Access Compliance Report

Public Rights-of-Way (Curb Ramps)

Intersection ID: 48946	Main Street: DAVID_JENNINGS_AV	Cross Street: MITCHELL_GRANT_WY	Location: E
ADA ID: 7272BB3DFDB4	Ramp Type: BlendTrans1	Initial Pass/Fail: Fail	Overall Compliance: No
		Severity Score: 10

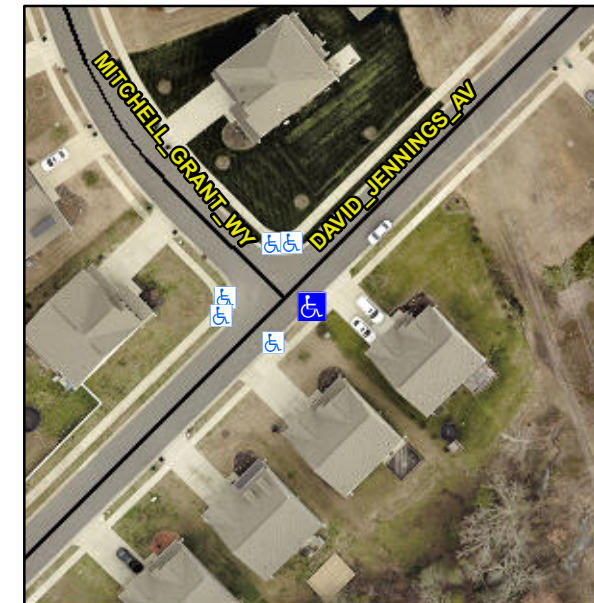
Not Found, R304.5.1

Compliance	Description	Data	Compliance	Description	Data
N/A	Ramp Length (in)	47.0	Yes	BlendTrans Slope (%)	2.2
No	Ramp Width (in)	47.5	Yes	BlendTrans XSlope (%)	2.9
N/A	Flare Type LT	N/A	N/A	Flare Type RT	N/A
N/A	Flare Slope LT (%)	N/A	N/A	Flare Slope RT (%)	N/A
N/A	Flare Traversable LT?	N/A	N/A	Flare Traversable RT?	N/A
N/A	Landing Length (in)	N/A	N/A	DWS Provided?	N/A
N/A	Landing Width (in)	N/A	N/A	DWS Contrast?	N/A
N/A	Landing Slope (%)	N/A	N/A	DWS Length (in)	N/A
N/A	Landing X Slope (%)	N/A	N/A	DWS Full Width?	N/A
N/A	Landing Curb? (Y/N)	N/A	N/A	DWS Offset (in)	N/A
N/A	Shared Landing?	N/A			
N/A	Gutter Ponding?	N/A	N/A	Gutter Slope (%)	N/A
N/A	Gutter Lip Ht (in)	N/A	N/A	Gutter X Slope (%)	N/A
N/A	Painted X Walk1?	No	N/A	Painted X Walk2?	N/A
	X Walk 1 Direction	To NW		X Walk 2 Direction	N/A
	X Walk 1 Width (in)	N/A		X Walk 2 Width (in)	N/A
	X Walk 1 Slope (%)	1.4		X Walk 2 Slope (%)	N/A
	X Walk 1 X Slope (%)	2.9		X Walk 2 X Slope (%)	N/A

N/A	Ramp inside XWalk1?	N/A	N/A	Ramp inside XWalk2?	N/A
	Road Slope (%)	2.9		Clear Space?	N/A
	Road X Slope (%)	1.4	N/A	Clear Space to XWalk (in)	N/A
N/A	Any Obstructions?	N/A	N/A	Storm Grate/Utility Hazard?	N/A
	Obstruction Type			Storm Grate/Utility Type	
		N/A			N/A
			Yes	Surface Condition? (G/P)	Good
			No	Curb Slope (%)	20.2

Remove & Replace Curb Ramp With Two New Directional Ramps or Equivalent.
